Subject: Issuance of Amendment No. 36 to Facility Operating License NPF-10
and Amendment No. 25 to Facility Operating License NPF-15
San Onofre Nuclear Generating Station, Units 2 and 3

ISSUANCE OF AMENDMENT NO. 36 TO FACILITY OPERATING LICENSE NPF-10
AND AMENDMENT NO. 25 TO FACILITY OPERATING LICENSE NPF-15
SAN ONOFRE NUCLEAR GENERATING STATION, UNITS 2 AND 3

SAFETY EVALUATION

SAN ONOFRE NUCLEAR GENERATING STATION, UNITS 2 & 3

Figure 3.1-1

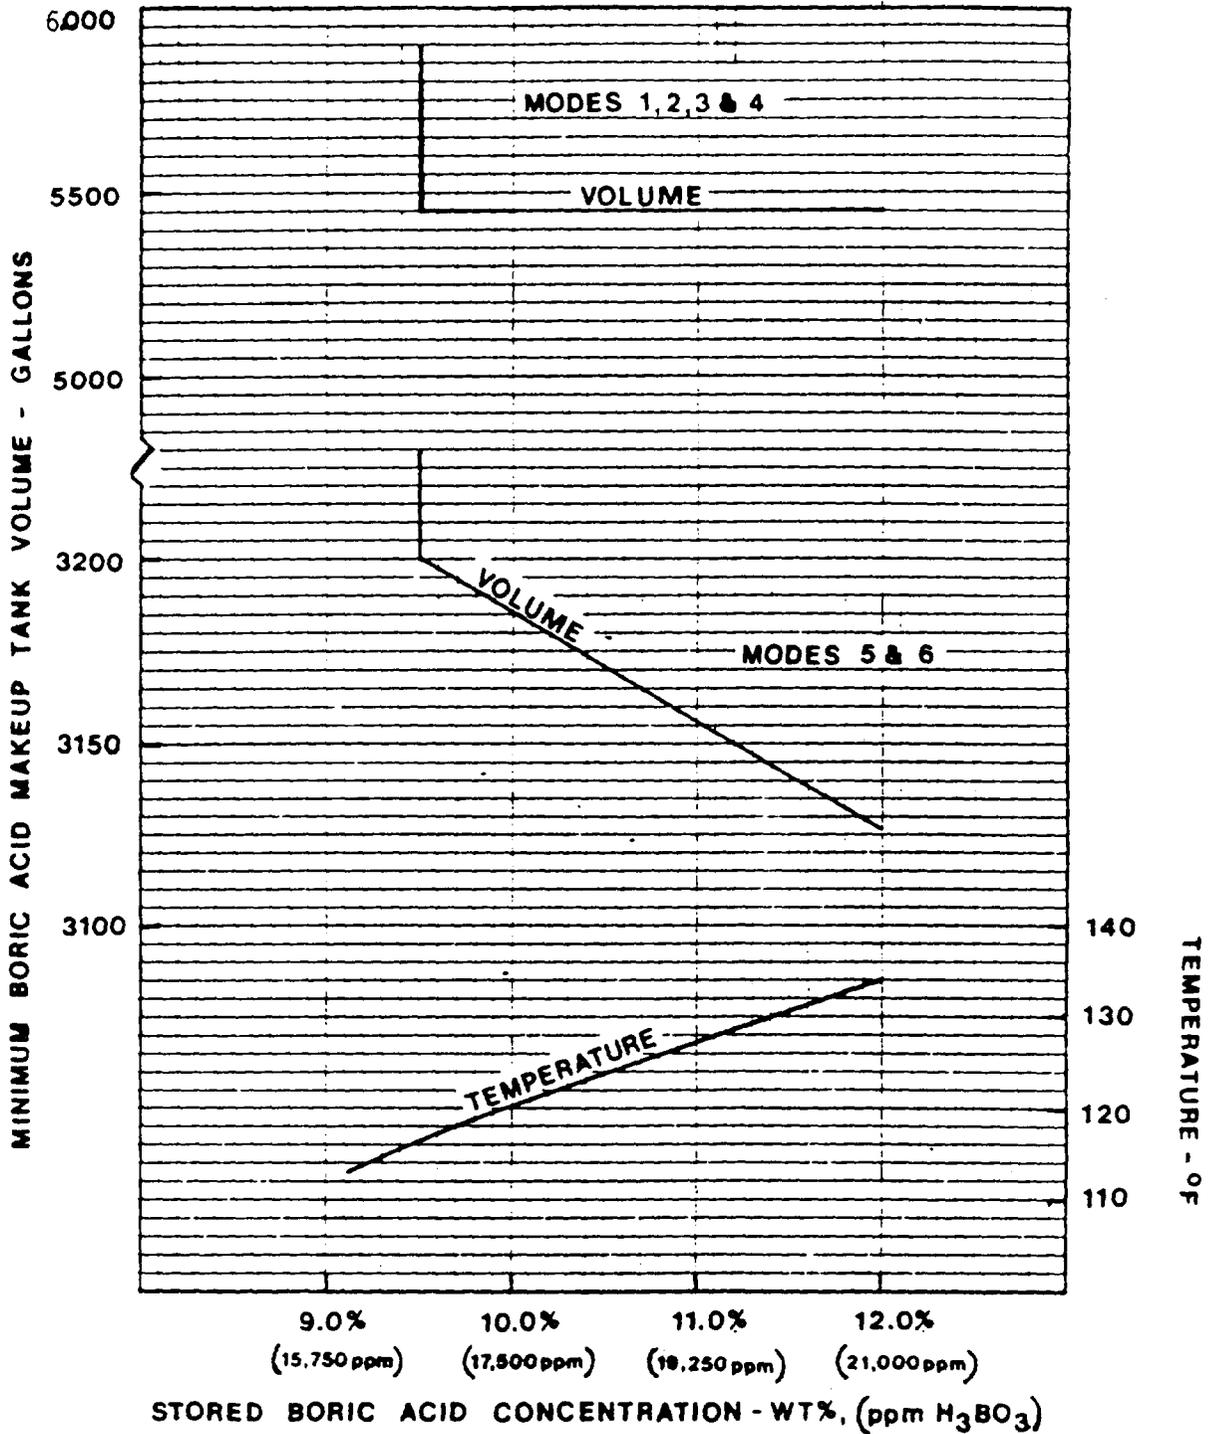
By letter dated May 9, 1985, SCE requested that the NRC staff revise San Onofre Unit 3 Technical Specifications 3.1.2.7, 3.1.2.8, and Bases 3/4.1.2 (PNC-163). Technical Specifications 3.1.2.7 and 3.1.2.8 require borated water source operability and specify volume, temperature and boron concentration requirements which assure that sufficient negative reactivity control is available during each mode of facility operation. These technical specifications define the minimum boric acid concentration. The amendment increases the boric acid storage tank volume/concentration and the minimum refueling water storage tank water volume specified by Technical Specification 3.1.2.7, consistent with the revised safety analysis associated with plant refueling and cycle 2 operation. In addition, the amendment decreases the boric acid storage tank water volume/concentration specified in Technical Specification 3.1.2.8, but nevertheless maintains the reactivity control required for cycle 2 operation, as is demonstrated by the cycle 2 safety analysis.

Core performance analyses of the cycle 2 reactor fuel management design show that the boron concentration required to (1) maintain the required shutdown margin after xenon decay and cooldown to 200°F, and (2) satisfy GDC-26, has increased due to the differences in core design and core performance characteristics from cycle 1. As a consequence, the minimum borated water volume in the refueling water storage tanks and the minimum boric acid makeup tank water volume must be revised for cycle 2 operation in order to meet the limiting conditions for operation on shutdown margin. The minimum water volume required in the boric acid makeup tank and refueling water storage tank in Modes 5 and 6 has been increased due to the increased Mode 5 shutdown margin required for cycle 2 operation. In addition, the Modes 1 through 4 boric acid makeup tank water volume requirement has been decreased in order to facilitate plant operation while nevertheless providing the required shutdown margin. For cycle 1 operation, borated water from the boric acid storage tank was used during plant shutdown to provide makeup for reactor coolant system (RCS) shrinkage. Makeup for RCS shrinkage during cycle 2 will be provided from the refueling water storage tank.

- 3.1.2.8 Each of the following borated water sources shall be OPERABLE:
- a. At least one boric acid makeup tank and at least one associated heat tracing circuit with the contents of the tanks in accordance with Figure 3.1-1, and
 - b. The refueling water storage tank with:
 1. A minimum contained borated water volume of 362,800 gallons above the ECCS suction connection,
 2. Between 1720 and 2300 ppm of boron, and
 3. A solution temperature between 40°F and 100°F.

Therefore, the proposed Technical Specifications 3.1.2.8 and B3/4.1.2 would specify the boric acid storage tank water volume/concentration and the refueling water storage tank volume required for negative reactivity control to be consistent with the requirements of cycle 2 operation. On this basis, the NRC staff finds the proposed change to be acceptable.
